# TOWN OF MOUNTAIN VILLAGE DESIGN REVIEW BOARD SPECIAL MEETING THURSDAY SEPTEMBER 15, 2016 10:00 AM 2nd FLOOR CONFERENCE ROOM, MOUNTAIN VILLAGE TOWN HALL 455 MOUNTAIN VILLAGE BLVD, MOUNTAIN VILLAGE, COLORADO REVISED AGENDA

RE: Conceptual Work Session for Review of a Principal Residence and Accessory

Dwelling Unit for Proposed Lot 387R1

Address: 127 Rocky Road

MAIN HOUSE MATERIAL REFERENCE IMAGES

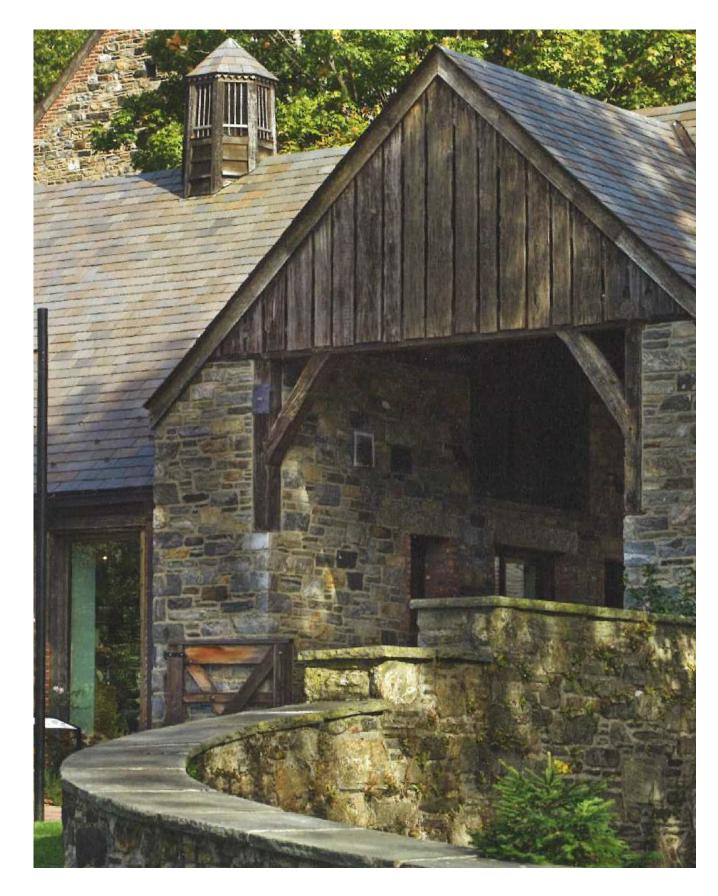
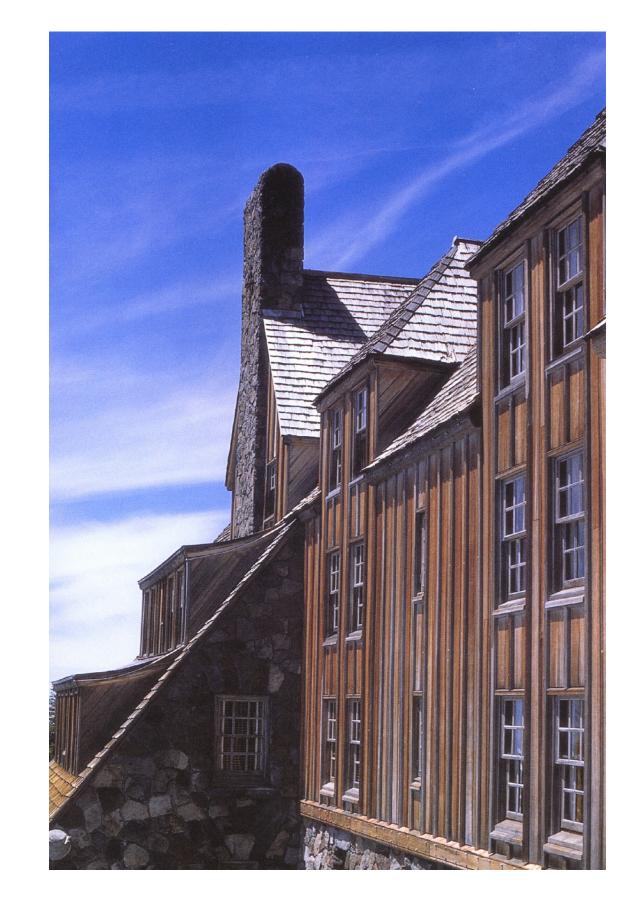
Both structures appear to be below the 35% requirement of stone required by the CDC. The principal residence is at 28%, but staff is unsure if this includes the stone site walls. The accessory structure is calling for only 15% stone, though the building is flanked by two stone retaining walls and steps. The applicant is trying to evoke the architecture of frontier structures from the area that did not feature a heavy grounded base as called for in the CDC.

BUILDING HEIGHT ANALYSIS

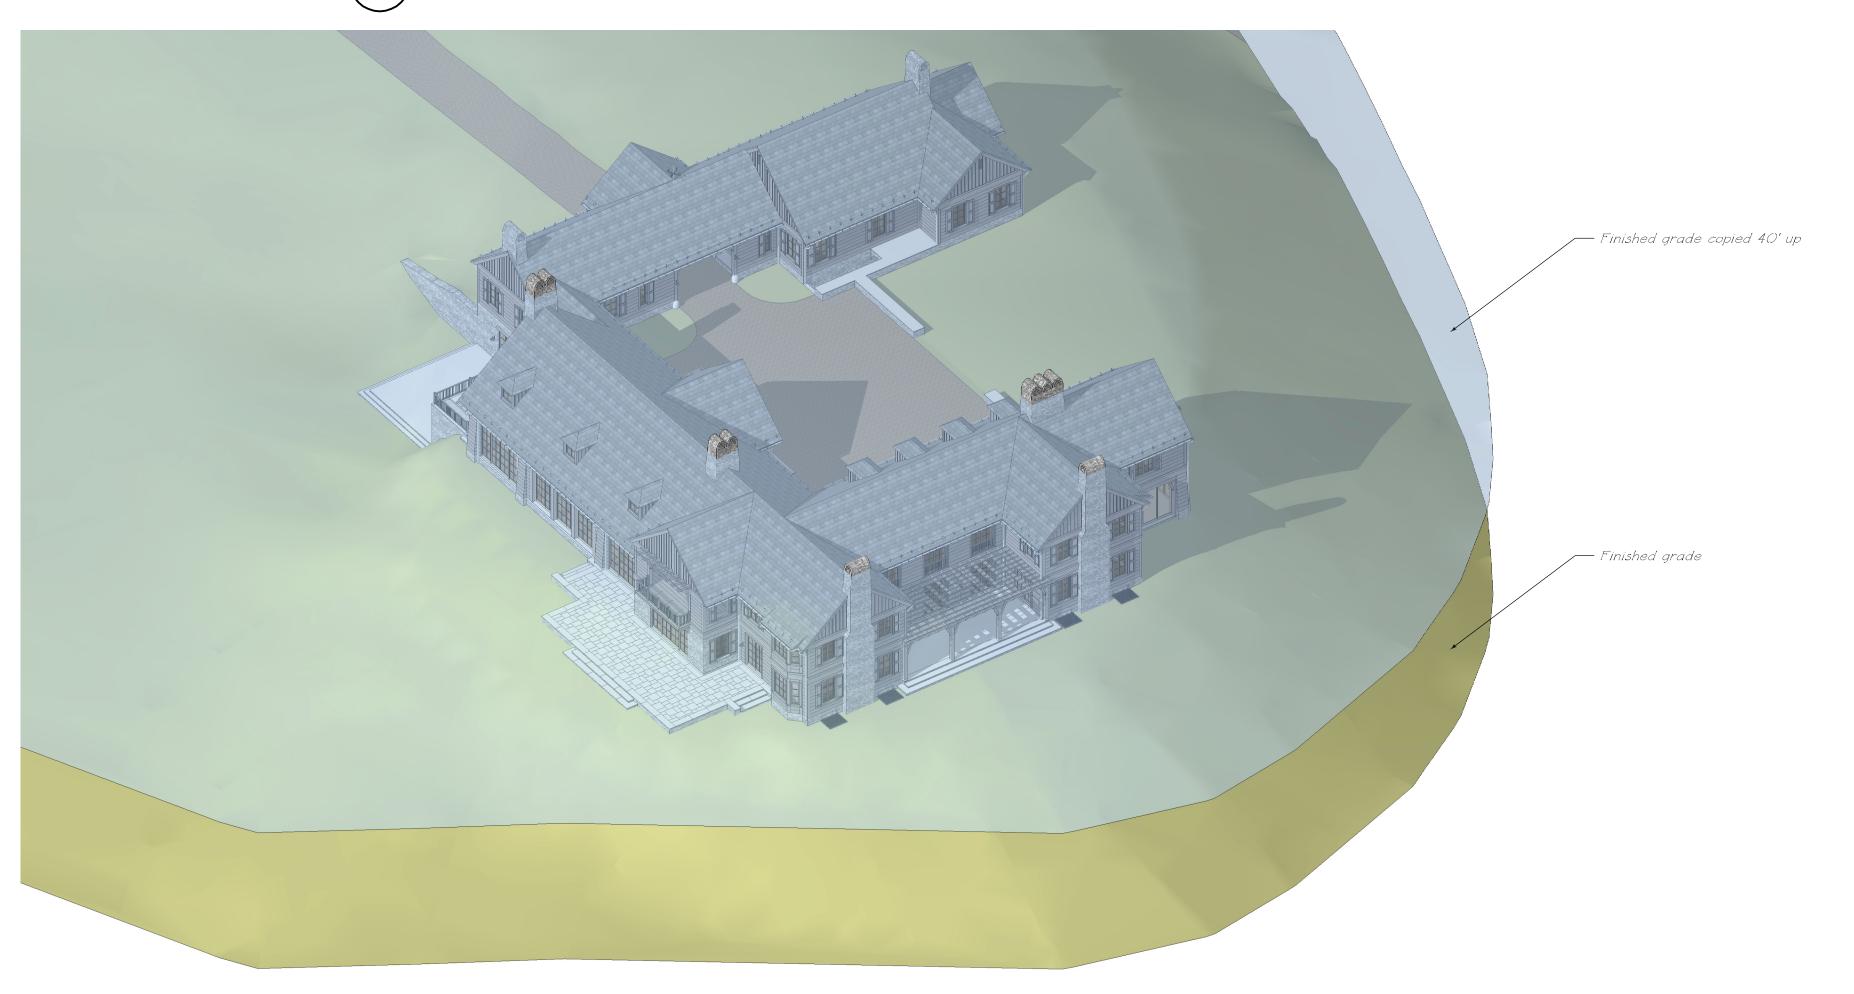
- A survey shall be provided to verify structure height is within the requirements for the principal structure.
- Only 15-28% of the exterior of the structures is stone where 35% is required.
- The principal residence does not blend with the topography; however other site planning goals are achieved through the plan.
